From: [REDACTED]
Sent: 15 July 2019 18:27
To: Planning <Planning@arun.gov.uk>
Subject: WA/48/19/RES - comments for reserved matters

Application WA/48/19/RES
Reserved matters – Arundel road/Fontwell Avenue

Photograph 2 – opposite view as above. The sheds to be demolished and replaced with the extended community centre along the boundary wall on the proposals. The width between the walls here is 3.05m

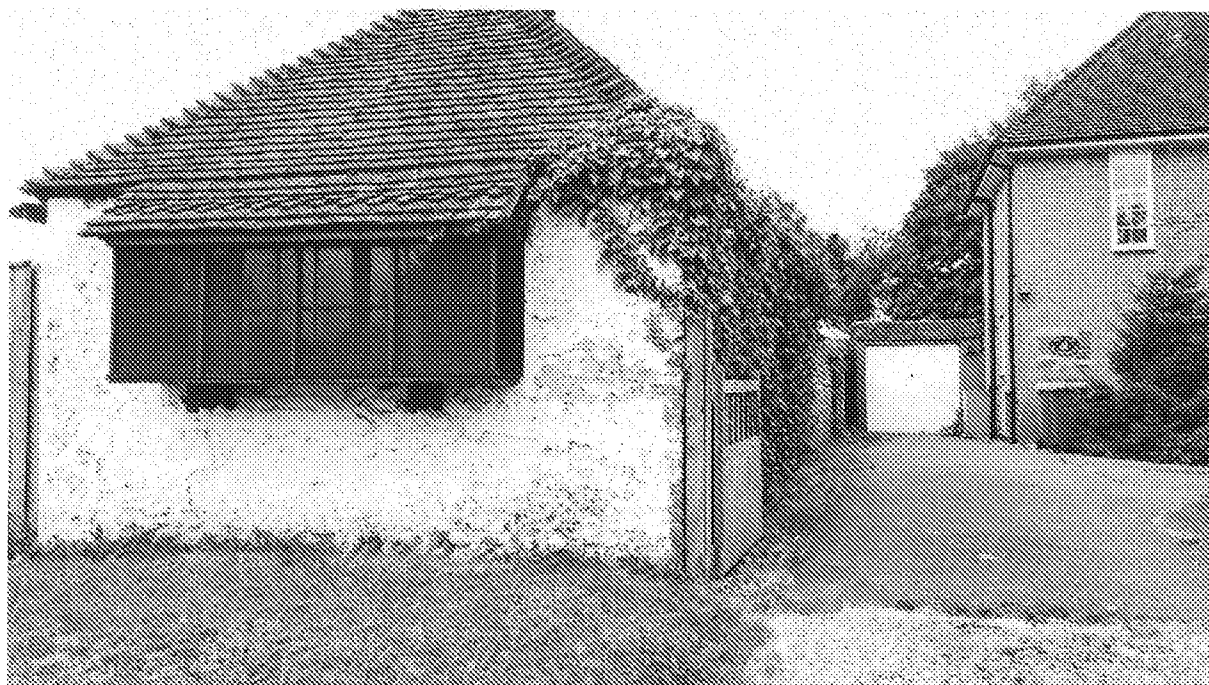
9. The bins are 'out of sight' of the community centre by being placed at the back of the car park but are immediately adjacent to my boundary. These will not be subject to the usual weekly residential collection and may result in rodent, insect and odour problems for the residents. The proximity to the residential properties also runs the risk of the bins being misused by residents and visitors to the site. Given the very close proximity to residential housing (and my patio area) I would suggest that the bin store is placed further from all residences and where any misuse will affect the community centre before residents
